AIA® Document G701™ – 2001

Change Order

| Vine Grove Elementary School-2011/2012 Renovations Vine Grove Elementary School 309 First Street Vne Grove, KY 40175 | | DATE: February 4, 2013 | ARCHITECT: <input type="checkbox"/> |

THE CONTRACT IS CHANGED AS FOLLOWS:

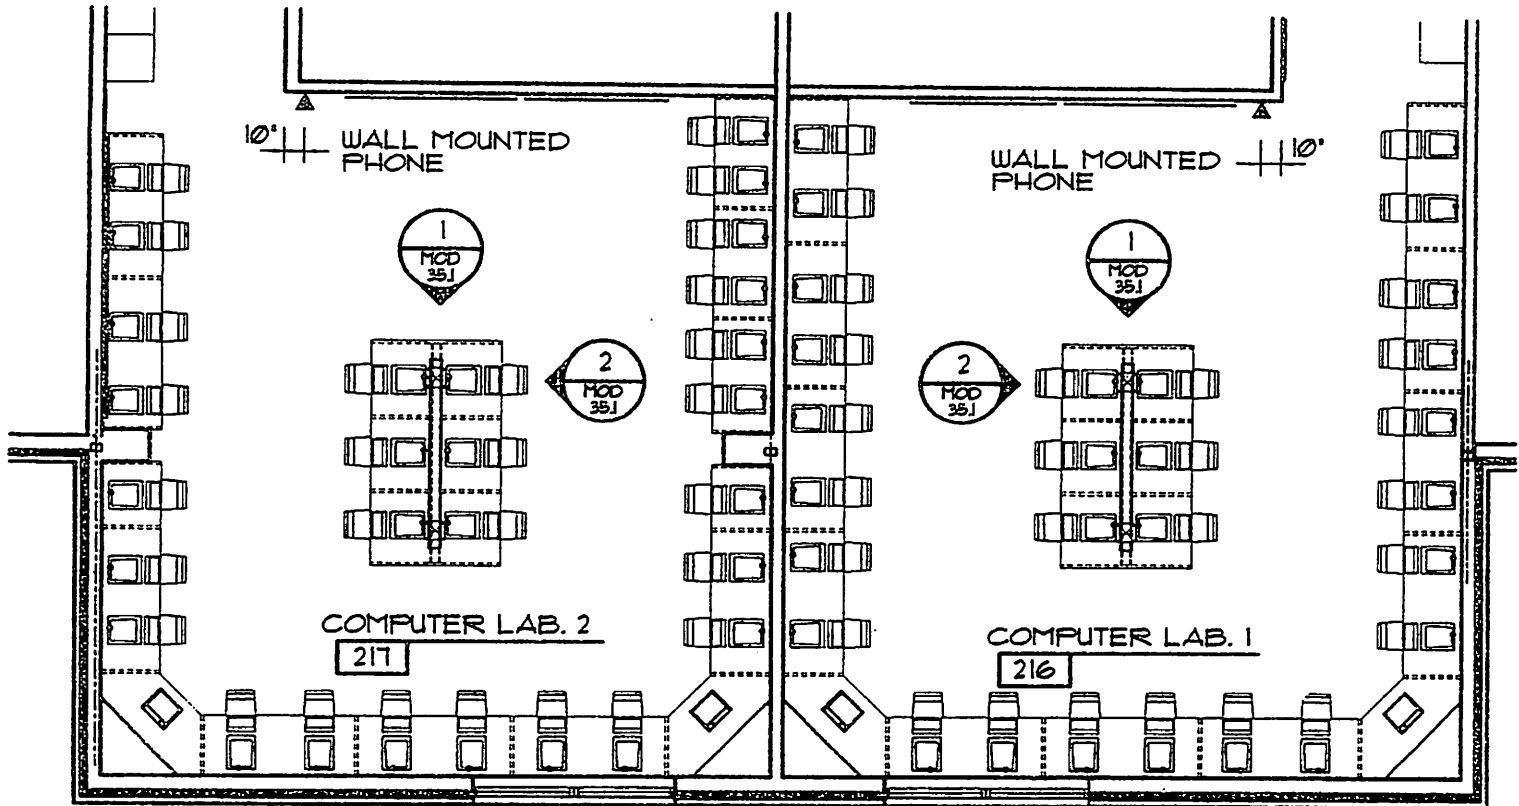
We reviewed the last drawings issued and found that WBW Engineering MOD E2.3 drawing dated November 22, shows two new electrical outlets in the exterior masonry wall @ 16" above the floor in Classroom 219.

| | <p>DRAWING MOD. 35</p> |

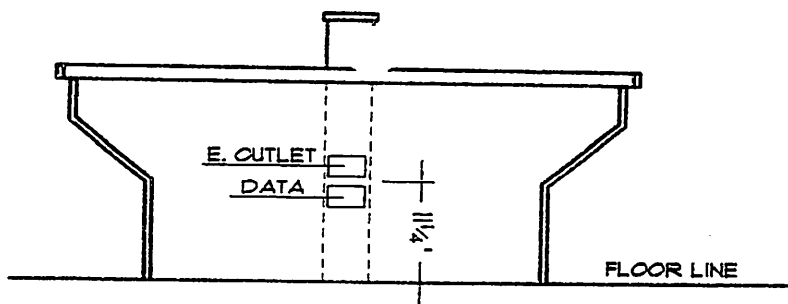
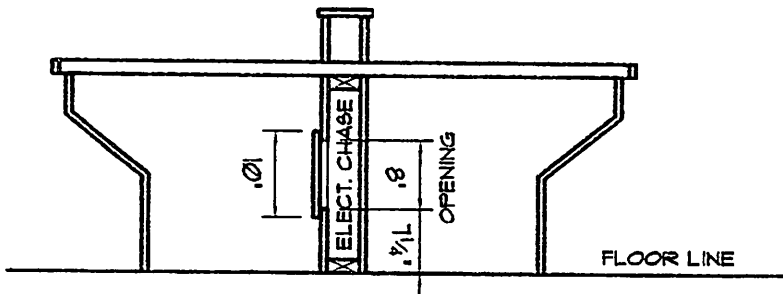
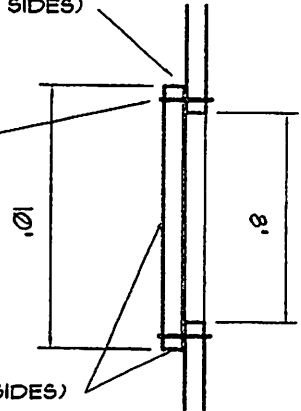
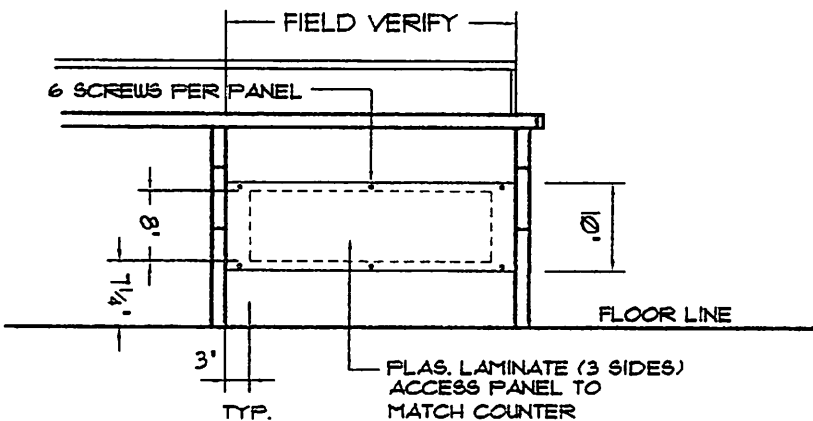
We reviewed the electrical requirements with Tim; per our instructions he is to provide 3 data and 1 electrical for the teacher work station along with all other controls and wiring related to the smart board. The receptacles are to be installed approximately half way from the bottom of the oak trim of the casework and the floor.

To provide this electricity and data an access panel will be required to be cut in the casework as shown on attached drawing. Please have Smith Laminating fabricate a plastic laminate cover panel with installation by McNutt Construction.

ENLARGED PLAN OF ADMIN. AREA

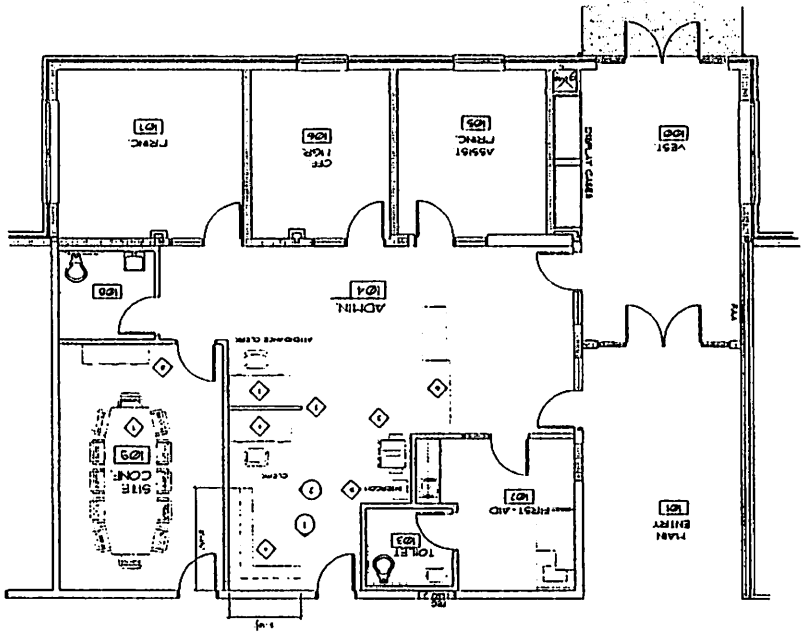
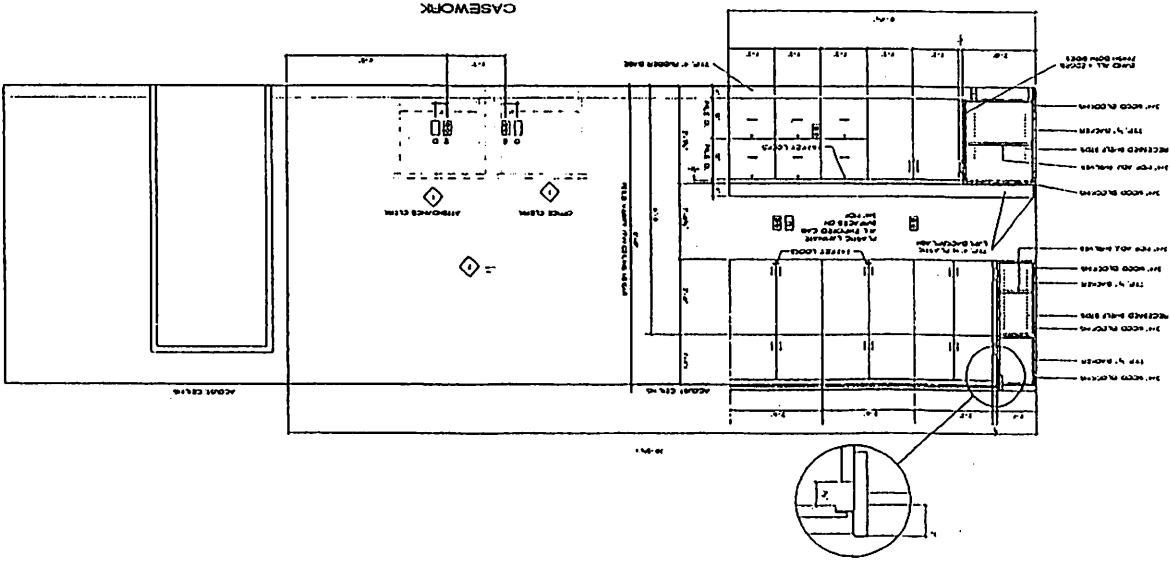
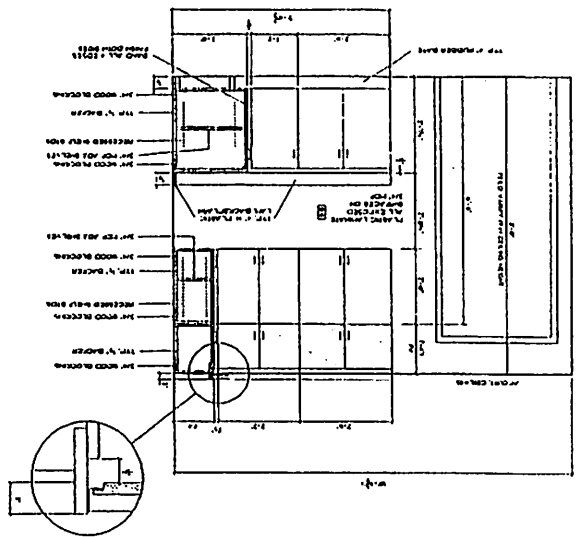
Per Mitchell Smith's question yesterday relating to the new Administration casework as it relates to the ceiling height as follows:

Based on above information we have revised MOD 25.1 to reflect this new height information. As you can see from attached drawing we have lowered the base cabinet and eliminated eight drawers. Please forward a credit based on this reduction in casework.

| | | MOD 8 |

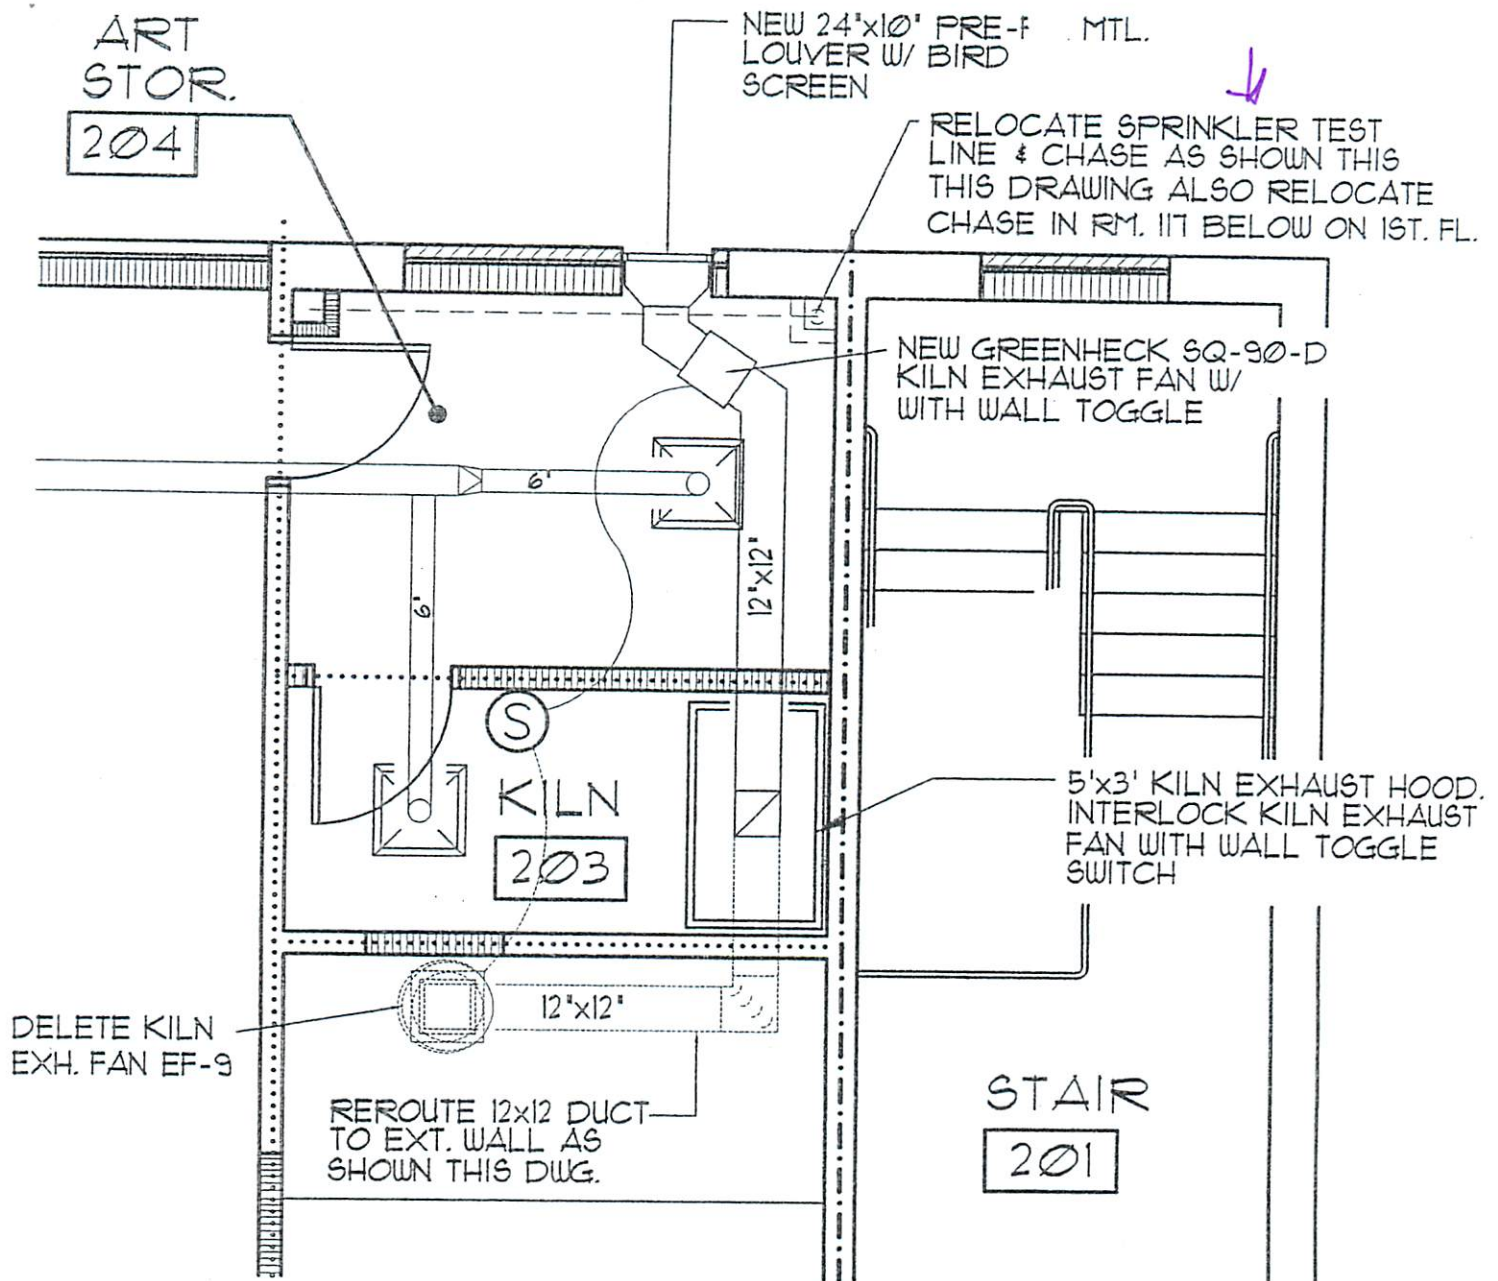
We would like to relocate new sprinkler test line, sprinkler line chase and reroute the duct work as shown on the attached Mod. 8 drawing dated July 14, 2011. Install the Greenheck SQ-90-D (see attachment) direct drive exhaust fan above the ceiling and provide a 24"x10" pre-finish metal louver with bird screen in the exterior masonry wall just below the soffit.

See attached drawing of roof curb for EF #9. The outside dimension of the curb is 17½ SQ the outside dimension of the base side to side is 23". The roof panel shown on A3.1 is 16" wide, will the roofer want to install the curb under the panel or on top? If on top will the curb need a notch for the rib, if a rib is required we will need more detail. Please Advise.

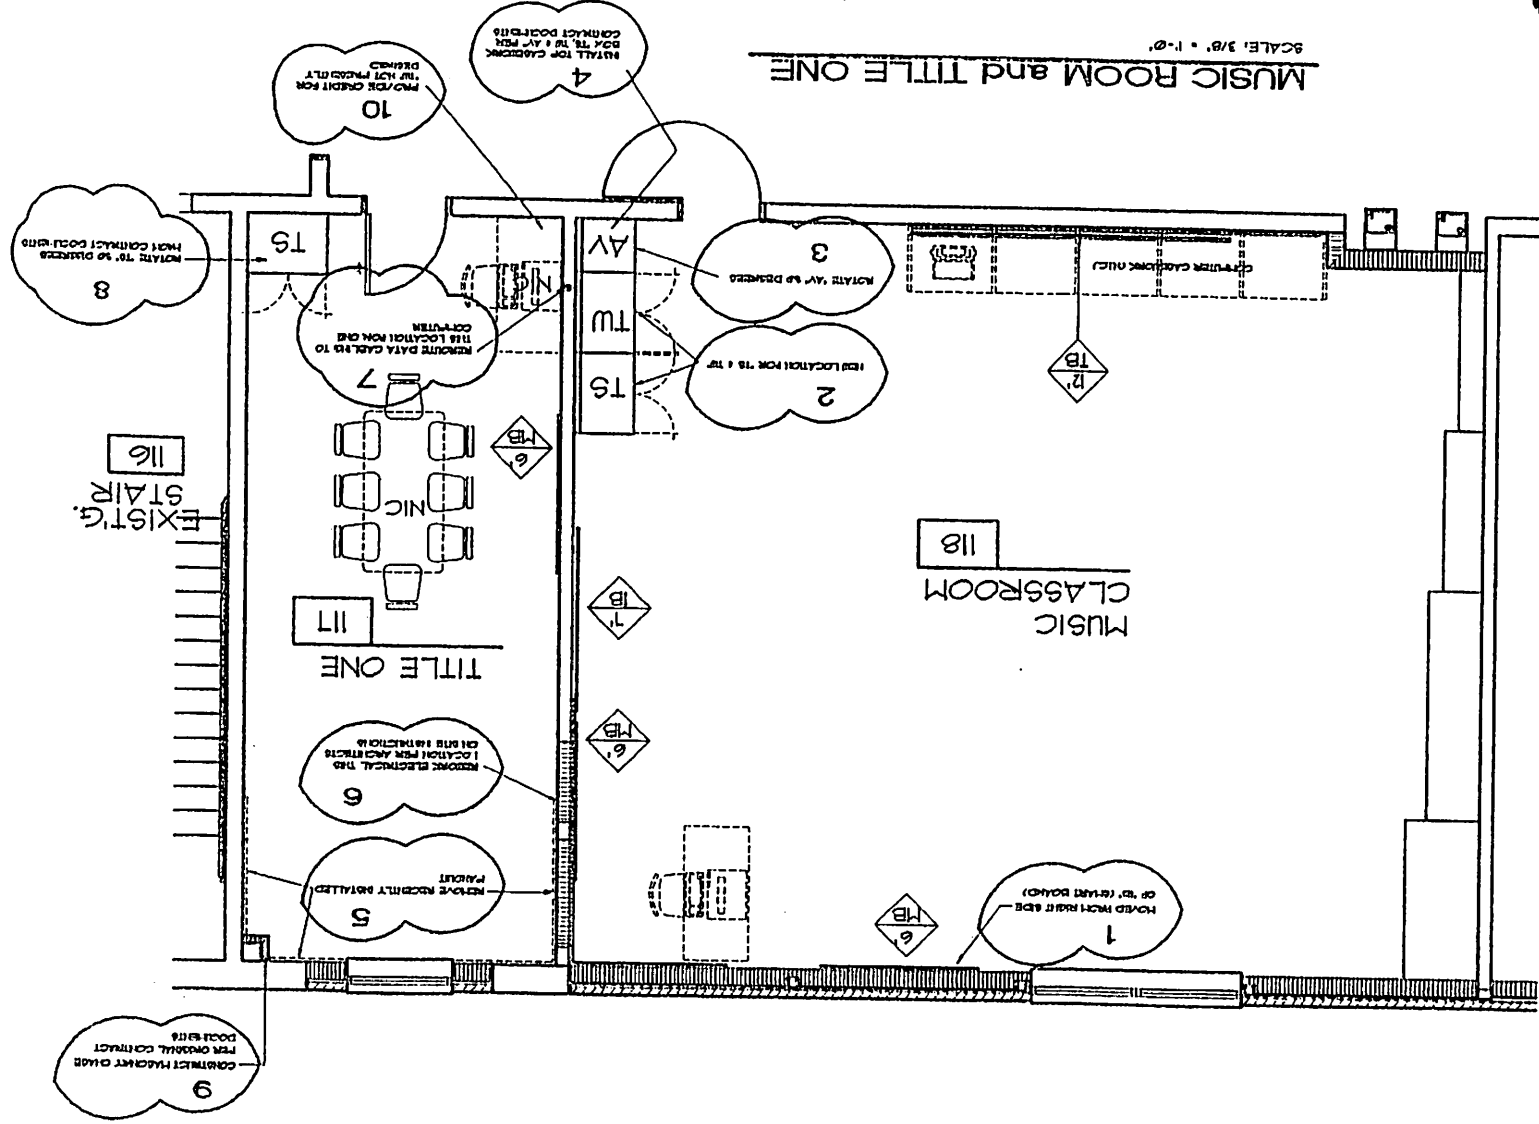
Attached to this email is our drawing MOD.231A. This drawing has changes to Music Room 118 and Title One 117 as noted below and as shown on the drawing.

1. The six foot marker board is to be relocated from its present location to the exterior wall were shown on drawing MOD 23.1A.
2. The teacher wardrobe and teacher storage units are to be relocate from presently location on exterior wall to location shown on drawing MOD 23.1A and adjacent to the audio visual cabinet.
3. Rotate audio visual casework 90 degrees from present location. If the present flex serving an electrical receptacle will not reach the present box then install the receptacle at the top of the open area.
4. Install top boxes for the AV/TW/TS plastic laminate units this room per contract documents.

5. Remove recently installed Panduit.
6. Rework electrical work this area in order to provide one fourplex receptacle.
7. Reroute data cabling laying unattached above ceiling tiles and provide a data outlet at location shown on drawing MOD 23.1A.
8. Rotate the Teacher Storage unit original scheduled for this location to face as shown on drawing MOD 23.1A. Please note this area is to have a top box.
9. Construct masonry chase for the piping in the corner of this room per original contract documents.
10. Provide credit for teacher wardrobe unit not desired at this time.
